Access Compliance Report

Public Rights-of-Way

Intersection ID: 3125	Main Street: JOHNSTON_OEHLER_RD	Cross Street: MOURNING_DOVE_LN	Location: SW
ADA ID: E9CC2DFFDF0A	Ramp Type: Perp	Initial Pass/Fail: Pass	Overall Compliance: No
Severity Score: 0			
Codes/Mitigation Info/Possible Solution		Field Measurements/Component Compliance

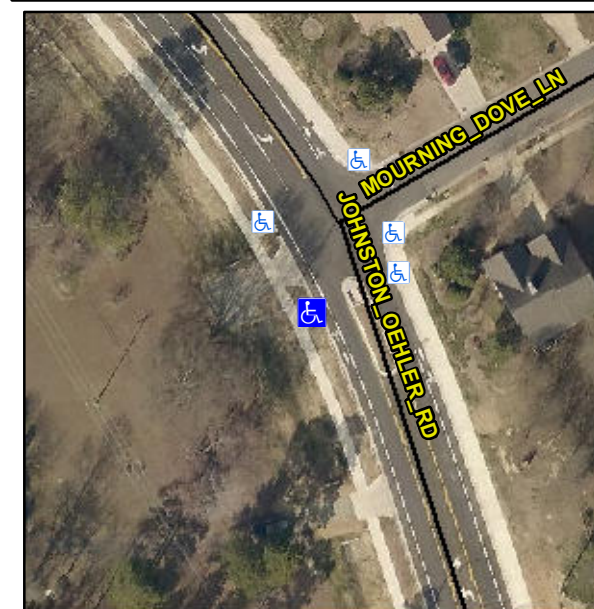
Remove & Replace Gutter.

R304.5.3

Compliance	Description	Data	Compliance	Description	Data
N/A	Ramp Length (in)	95.0	Yes	Ramp Slope (%)	7.6
Yes	Ramp Width (in)	98.0	Yes	Ramp XSlope (%)	1.3
Yes	Flare Type L	Curbed_NoWalkSurface	Yes	Flare Type RT	N/A
Yes	Flare Slope LT (%)	N/A	N/A	Flare Slope RT (%)	N/A
N/A	Flare Traversable LT?	No	N/A	Flare Traversable RT?	No
Yes	Landing Length (in)	72.0	Yes	DWS Provided?	Yes
Yes	Landing Width (in)	98.0	Yes	DWS Contrast?	Yes
Yes	Landing Slope (%)	0.8	Yes	DWS Length (in)	24.0
Yes	Landing X Slope (%)	1.9	Yes	DWS Full Width?	Yes
N/A	Landing Curb? (Y/N)	No	Yes	DWS Offset (in)	0.0
N/A	Shared Landing?	No			
Yes	Gutter Ponding?	No	Yes	Gutter Slope (%)	0.8
Yes	Gutter Lip Ht (in)	0.0	No	Gutter X Slope (%)	2.7
N/A	Painted X Walk1?	No	N/A	Painted X Walk2?	N/A
	X Walk 1 Direction	To E		X Walk 2 Direction	N/A
N/A	X Walk 1 Width (in)	N/A	N/A	X Walk 2 Width (in)	N/A
	X Walk 1 Slope (%)	1.3		X Walk 2 Slope (%)	N/A
	X Walk 1 X Slope (%)	2.5		X Walk 2 X Slope (%)	N/A
